Vista and D950 Service News July 2008

1 FADER CARE (VALID FOR ALPS FADERS 1.950.044)

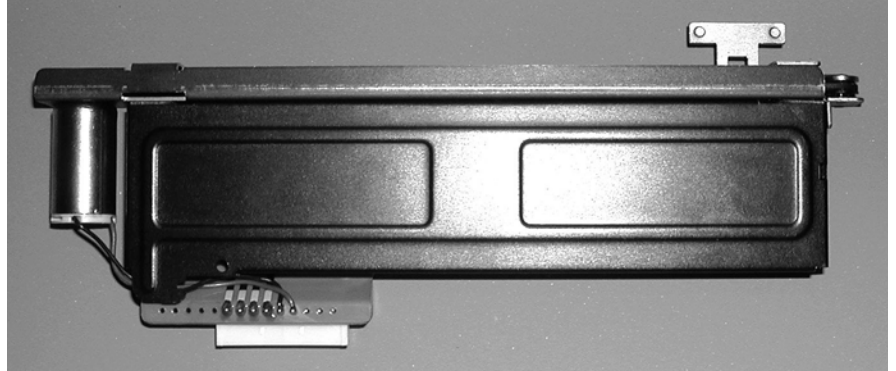
Further investigations with a number of returned faders at EMPA, the material sciences lab of the ETH, showed that some of the faders had remains of silicon oil from the lubrication of the sliders on the fader tracks. After consultation with our supplier we updated our service note for fader maintenance : in case of touch problems, cleaning with isopropyl alcohol is now recommended (only dry cleaning before). See updated ALPS Fader maintenance document (Vista service notes) for details.

- Regular cleaning of faders is good practice, and could be combined with a yearly overall maintenance check. In case of touch problems the use of isopropyl alcohol is recommended.

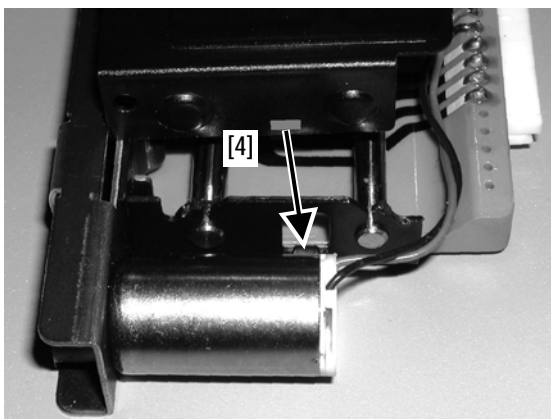
- [2] Normally, dry cleaning is sufficient (dust). To do so, use a clean, lint-free cloth and rub firmly along the track in order to ensure that no debris remains. If problems with the touch function were observed, use of isopropyl (rubbing) alcohol is recommended.
